CHANGE NO. 14 TO THE TECHNICAL SPECIFICATIONS

FACILITY LICENSE NO. DPR-28

VERMONT YANKEE NUCLEAR POWER CORPORATION

Replace pages issued with Changes Nos. 10 (dated August 24, 1973), 11 (dated October 5, 1973), and 12 (dated November 16, 1973) with the attached pages 94a, 94b, 94c, 97a, and 97b.

Figure 3.5.1.A Maximum Allowable Planar LHGR

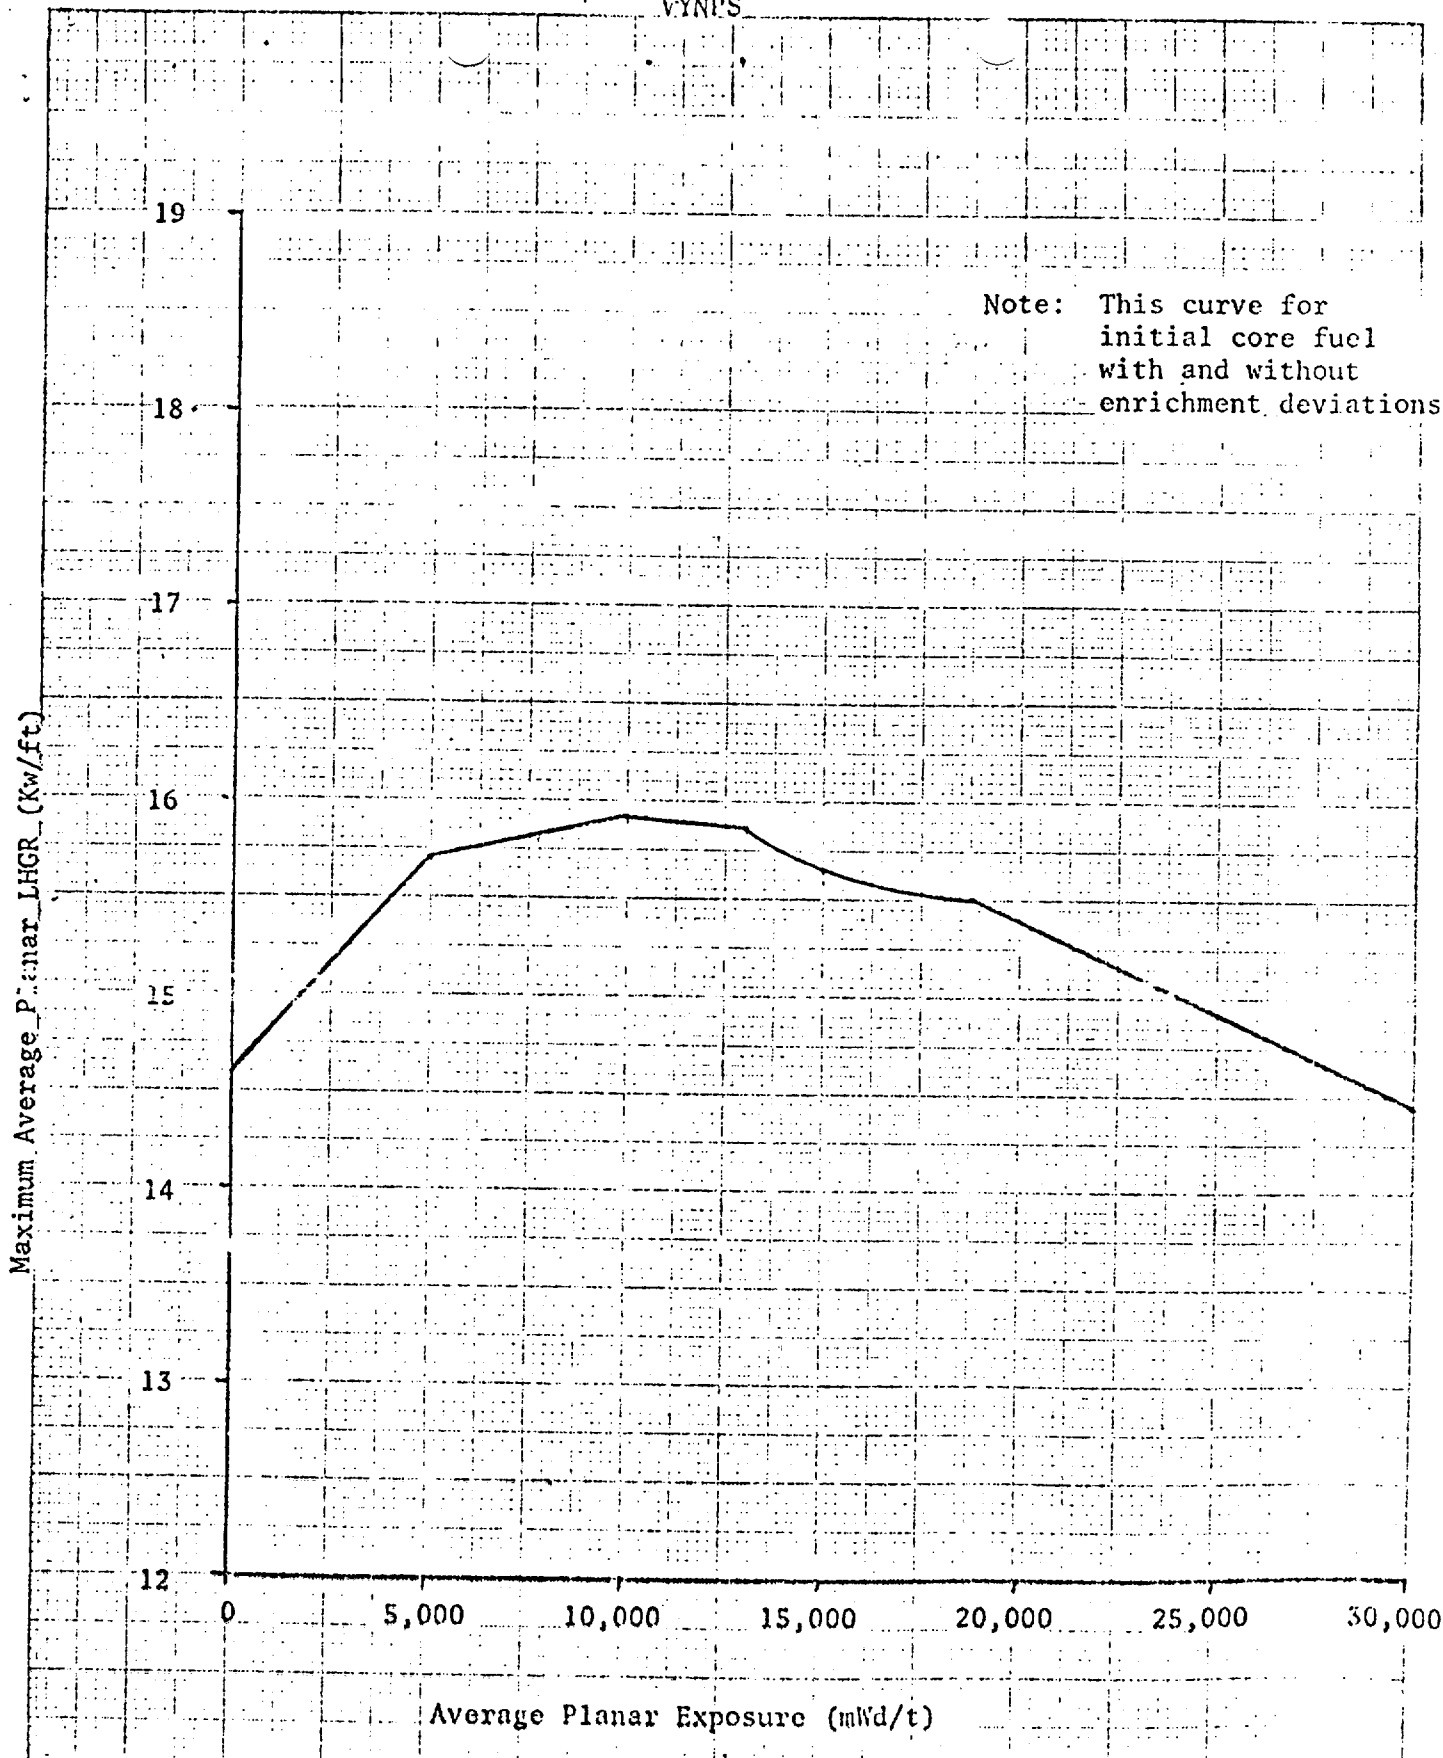
Your letter dated December 13, 1973, proposed changes to the Technical Specifications of Facility License No. DPR-28 for the Vermont Yankee Nuclear Power Station that would increase the maximum average planar linear heat generation rate (MAPLHGR). These changes in the MAPLHGR are the result of changes in the fuel densification model by the General Electric Company as reported in NEDO-20181, "GEGAP III A Model for Prediction of Pellet-Clad Thermal Conductance in BWR Fuel Rods", dated November 1973, and its supplement NEDC-20181 Supplement 1 (Proprietary) dated November 1973. Modifications to the proposed model were made by the Regulatory staff and transmitted by our letter dated December 5, 1973, to you.

The changes in the fuel densification model provide for an exposure dependent gap conductance and time-dependent fuel densification. The Regulatory staff evaluation of these changes is reported in "Supplement 1 to the Technical Report on Densification of General Electric Reactor Fuels", dated December 14, 1973, and our Safety Evaluation dated December 14, 1973, for the Vermont Yankee Nuclear Power Station which were provided to you by our letter of December 21, 1973.

During steady state power operation, the average linear heat generation rate (LHGR) of all the rods in any fuel assembly, as a function of average planar exposure, at any axial location, shall not exceed the maximum average planar LHGR shown in Figure 3.5.1.

The maximum average planar LHGR shown in Figures 3.5.1.A and 3.5.1.B is the same as that shown on the curve labeled "Ω" (Omega) on Figures 1-G and 2-G in the General Electric letter of J. A. Hinds to V. A. Moore, "Plant Evaluations with GEGAP-III," dated December 12, 1973, based on calculations employing the models described in the General Electric reports NEDM-10735 as modified by the General Electric report NEDO-20181.
